Zilker Neighborhood Association

November 4, 2021

Re: Agenda item 56, Rezoning of 2700 South Lamar, Case C14-2020-0144

Figure 4
Entering from the South (option 2)

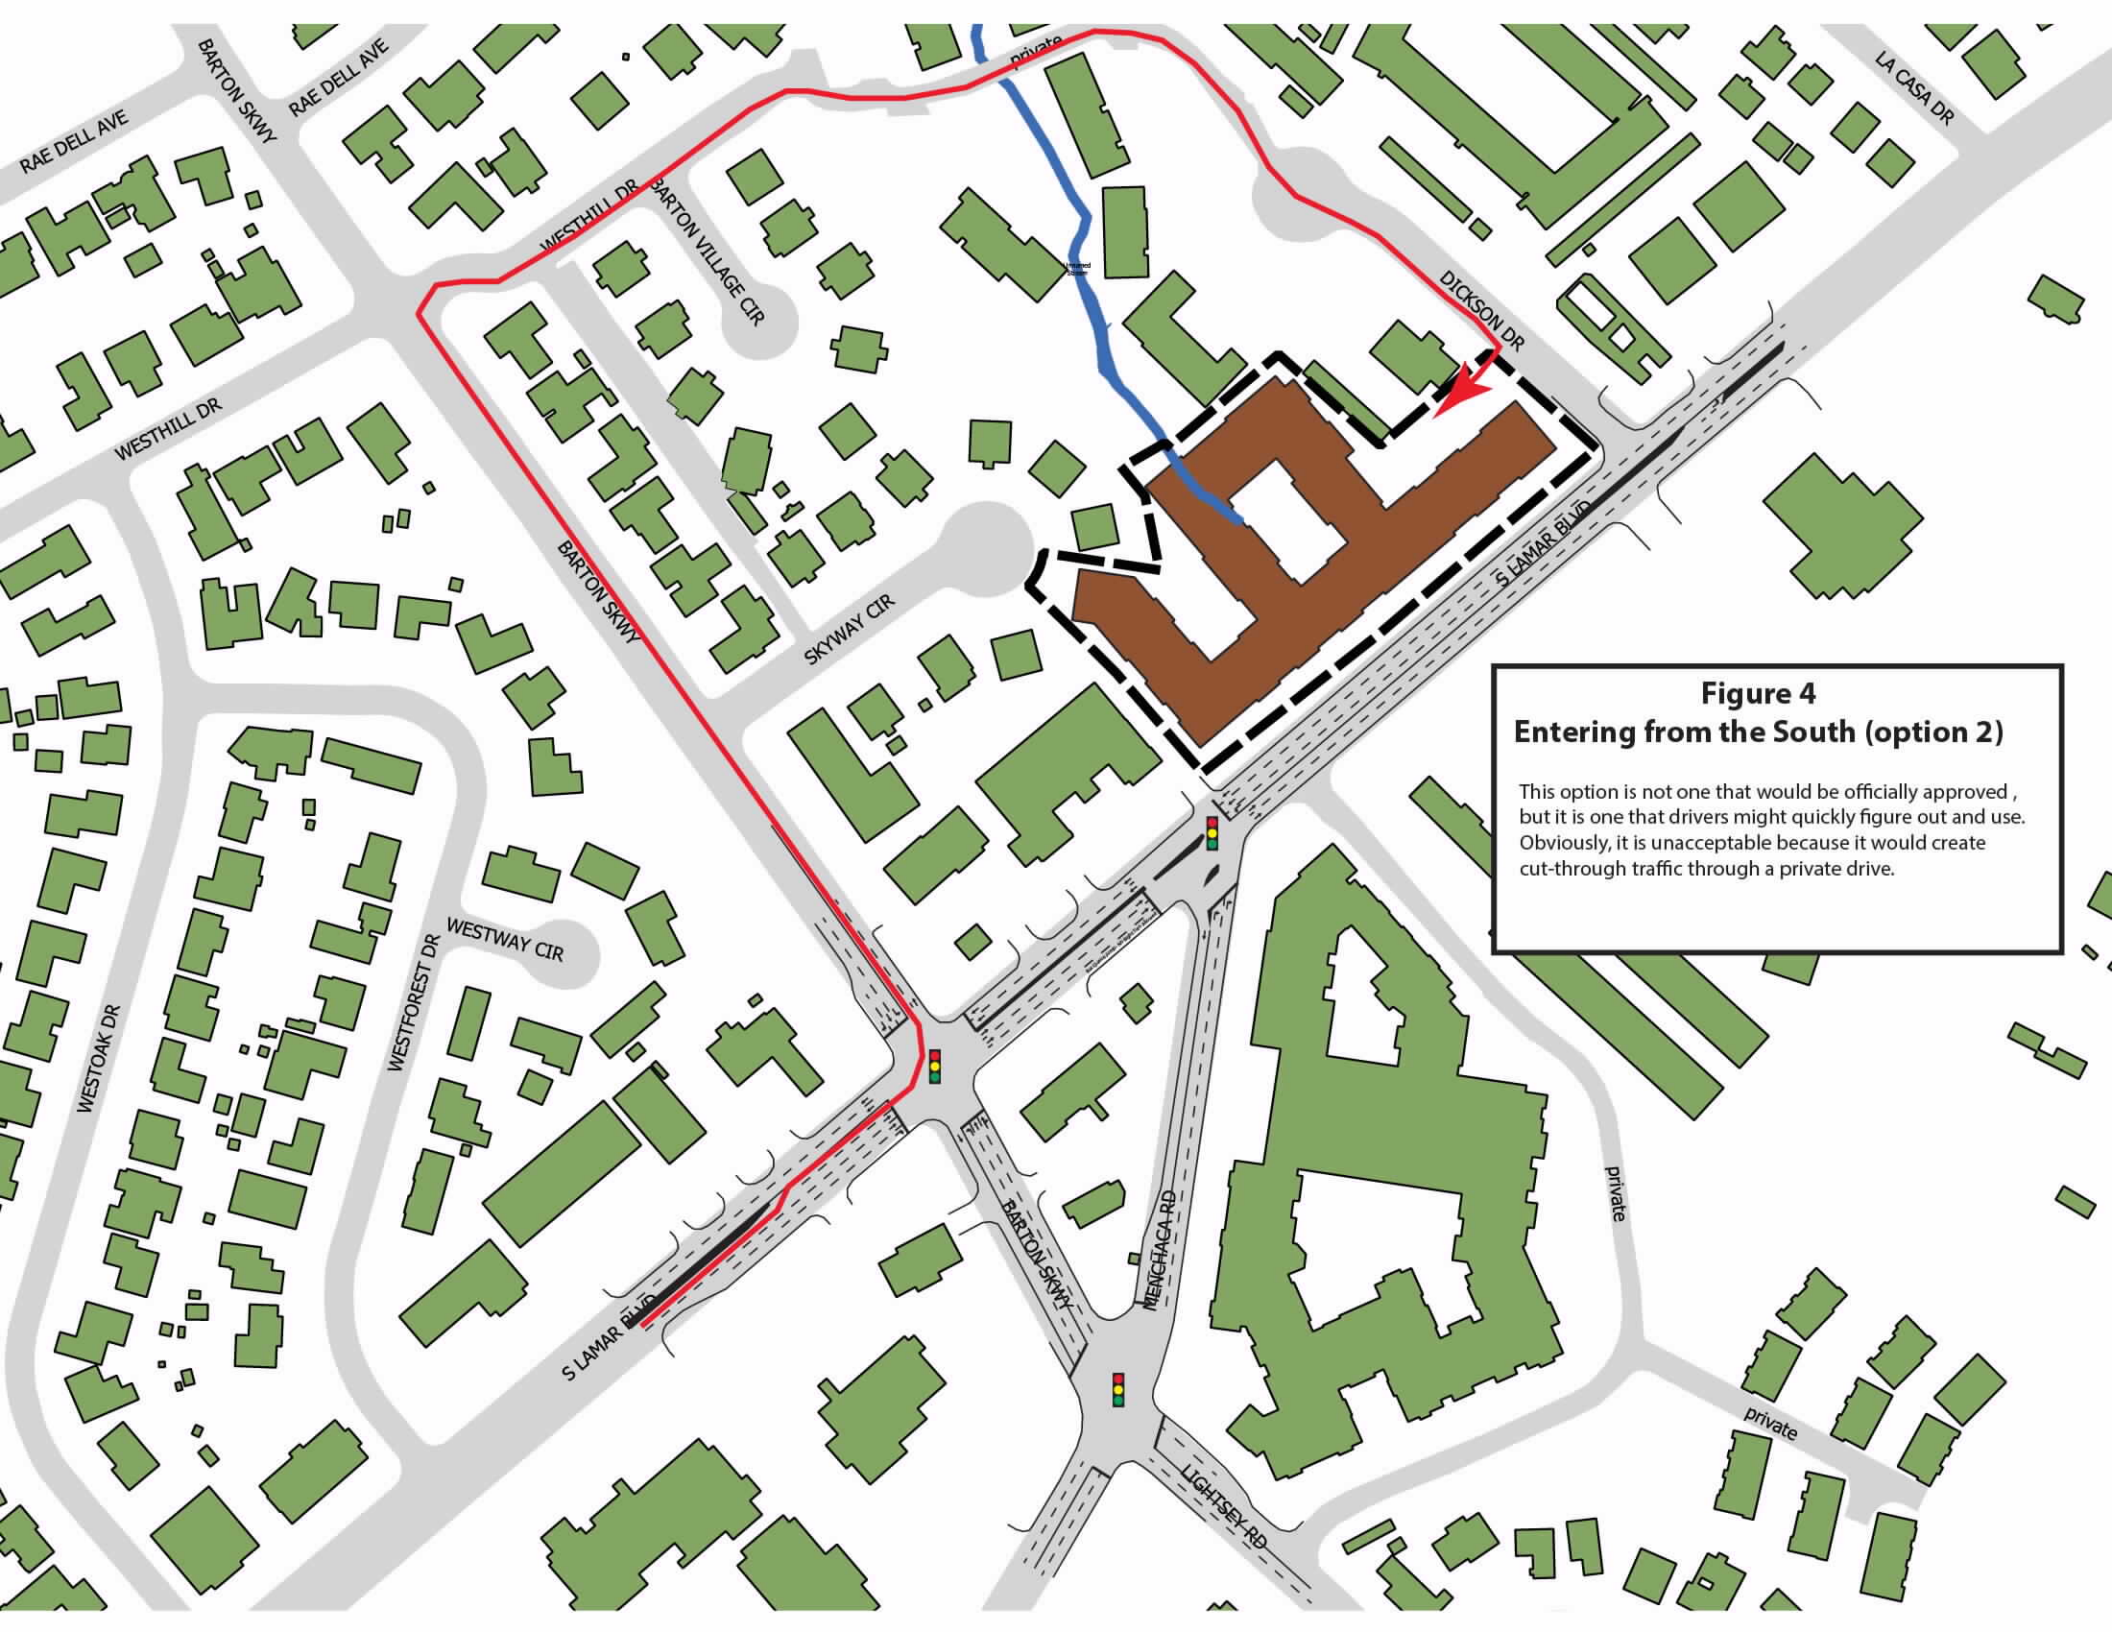
This option is not one that would be officially approved , but it is one that drivers might quickly figure out and use. Obviously, it is unacceptable because it would create cut-through traffic through a private drive.

Figure 5
Entering from the South (option 3)

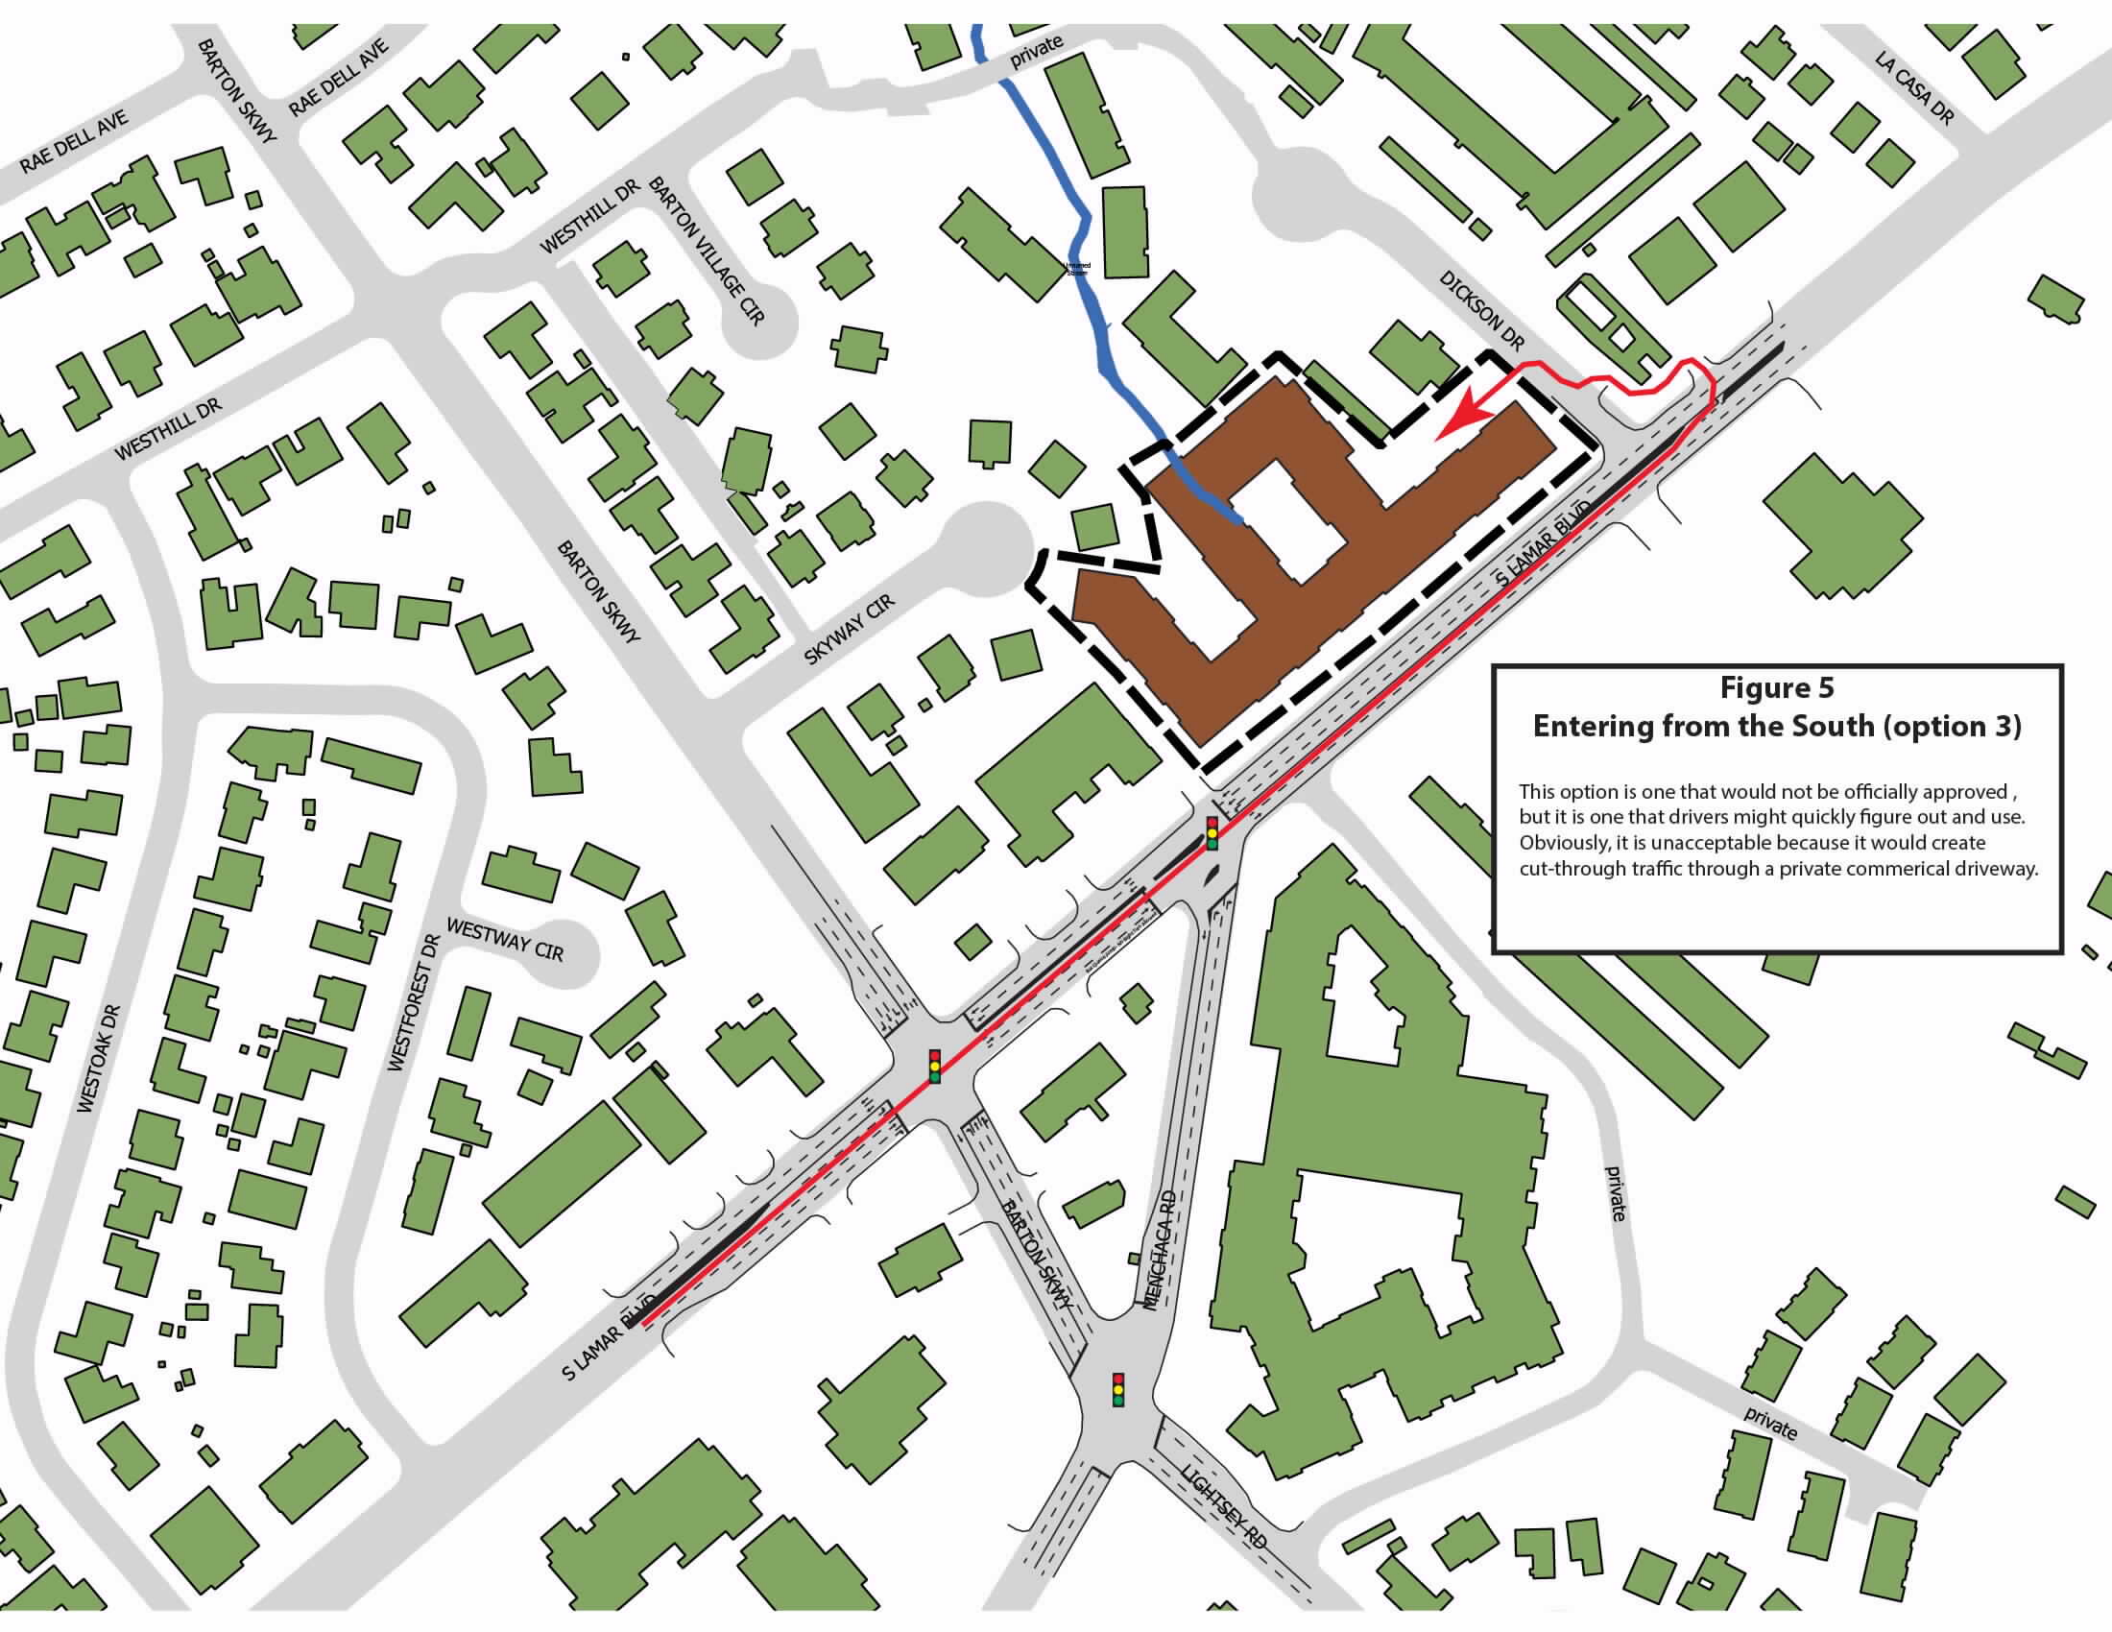
This option is one that would not be officially approved , but it is one that drivers might quickly figure out and use. Obviously, it is unacceptable because it would create cut-through traffic through a private commerical driveway.

Figure 6
Barton Springs Zone

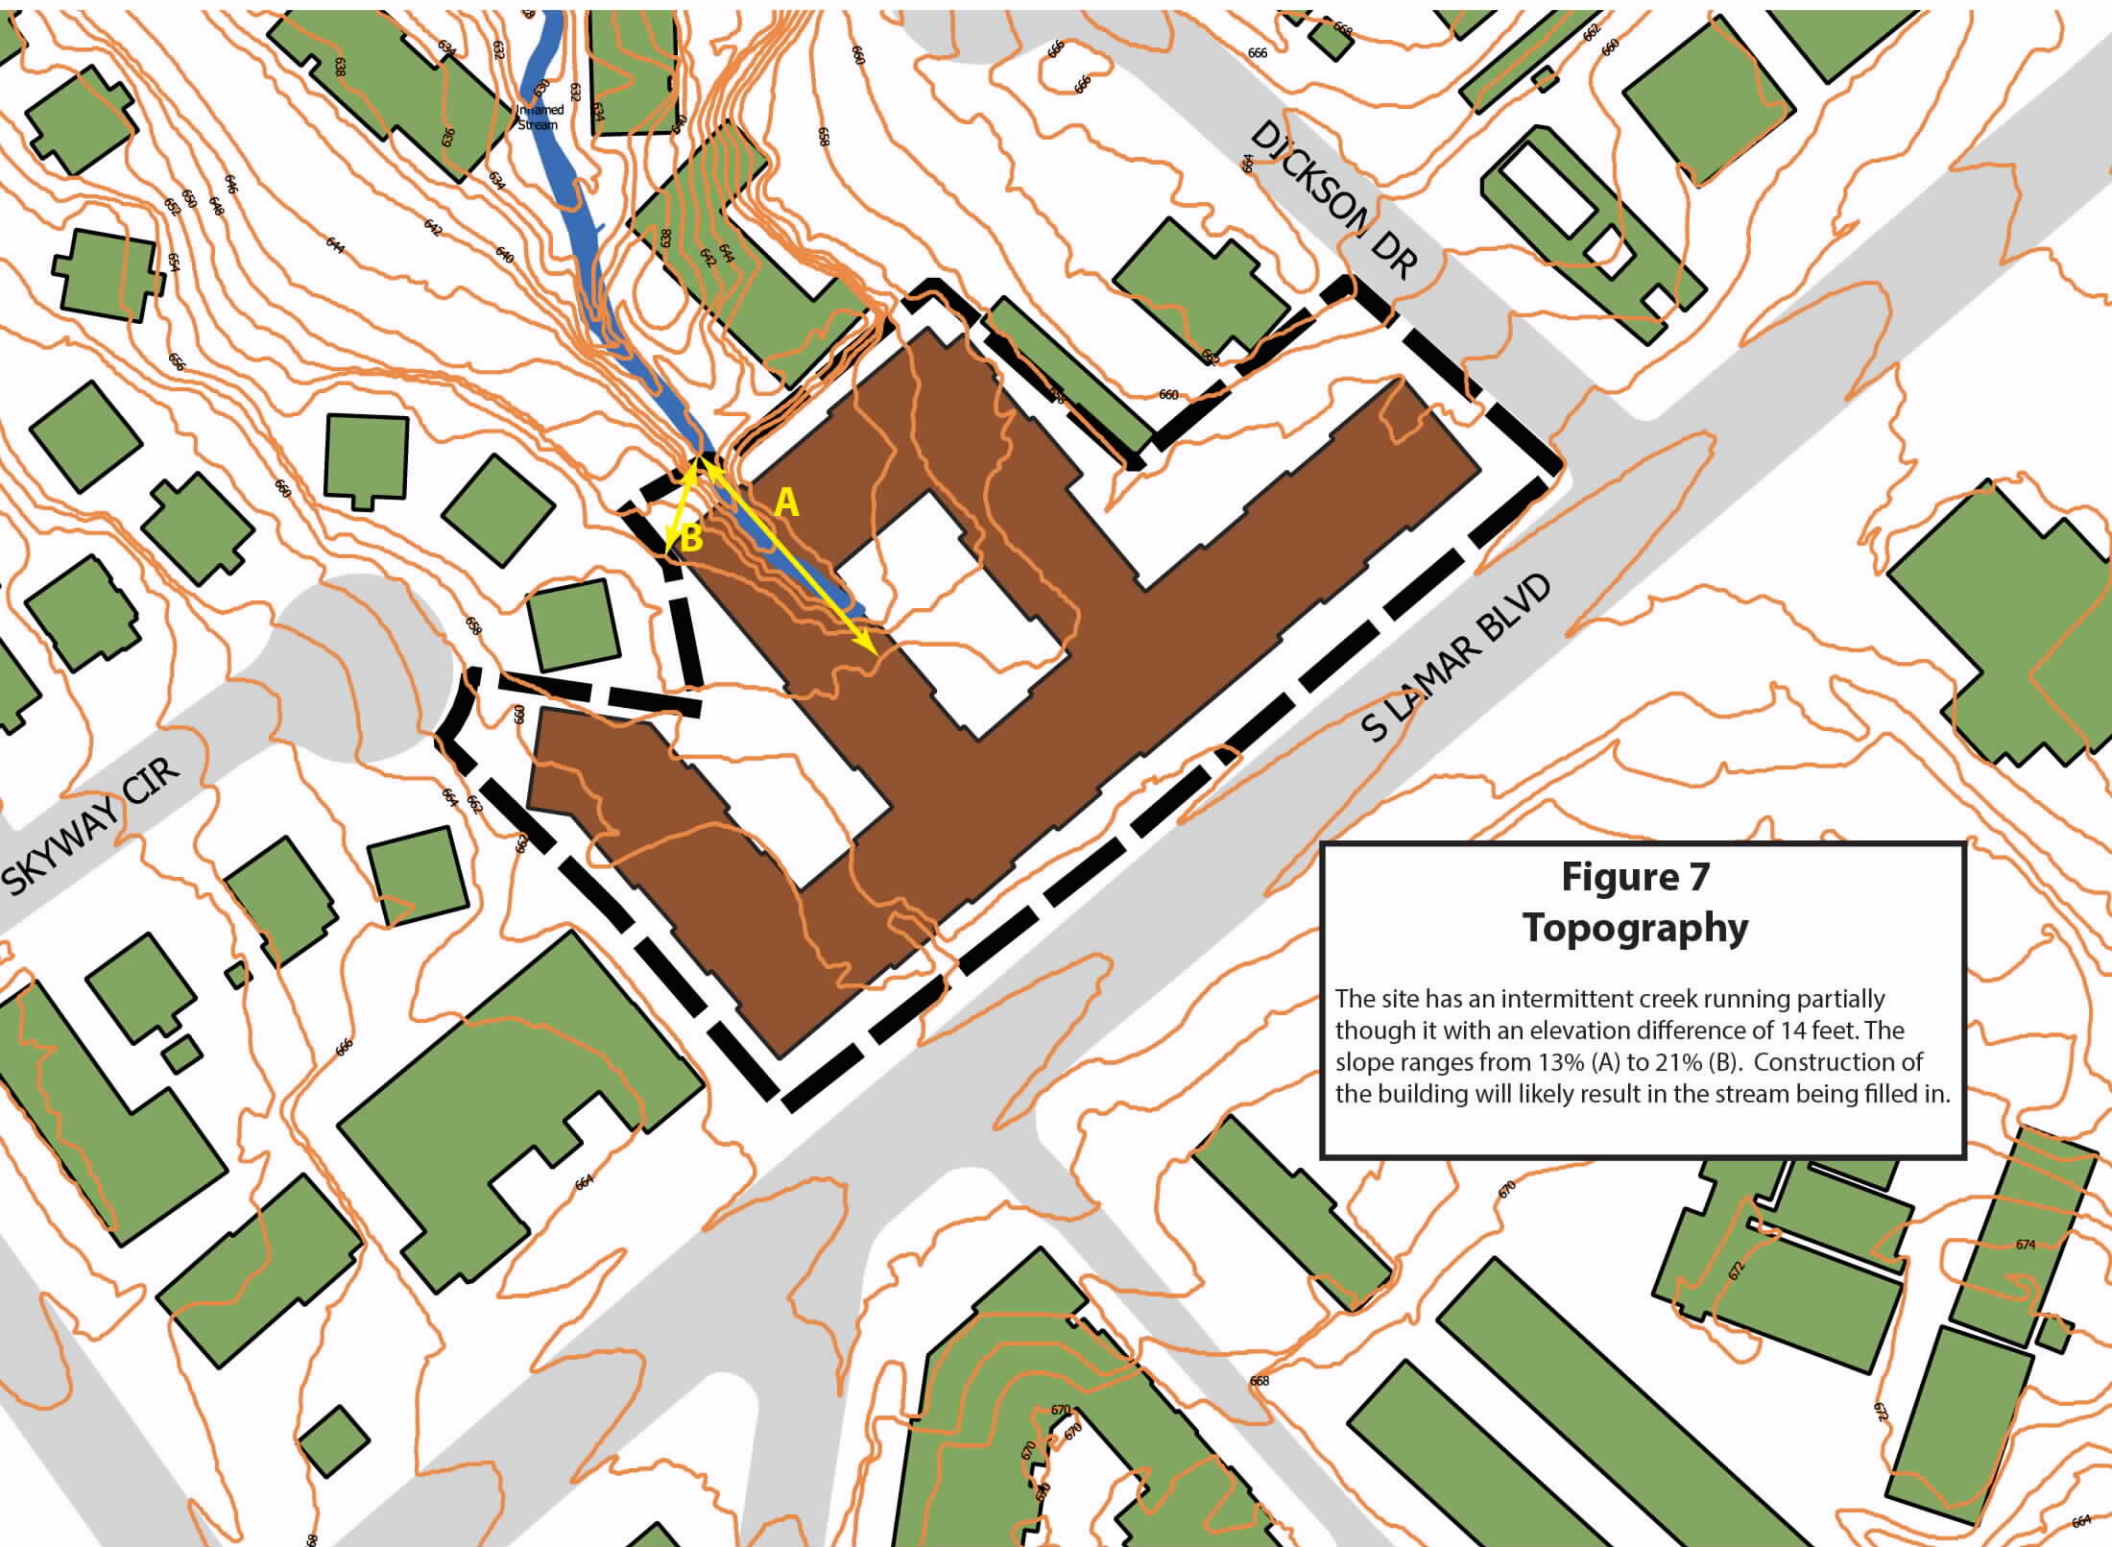
Much of the site is located over the Barton Springs Zone (see Figure 6) and, according to the City staff report, is subject to 15% impervious cover limit of the Save Our Springs (SOS) Ordinance. To build the proposed project, the owners must apply for a redevelopment exception under Code Section 25-8-26. As a multifamily residential project, it would require a public hearing and City Council approval. According to the Redevelopment Exception, the City Council shall consider the following factors in determining whether to approve a proposed redevelopment:

The area shaded in blue shows the location of the Barton Springs Zone and is environmentally sensitive and subject to the SOS ordinance.
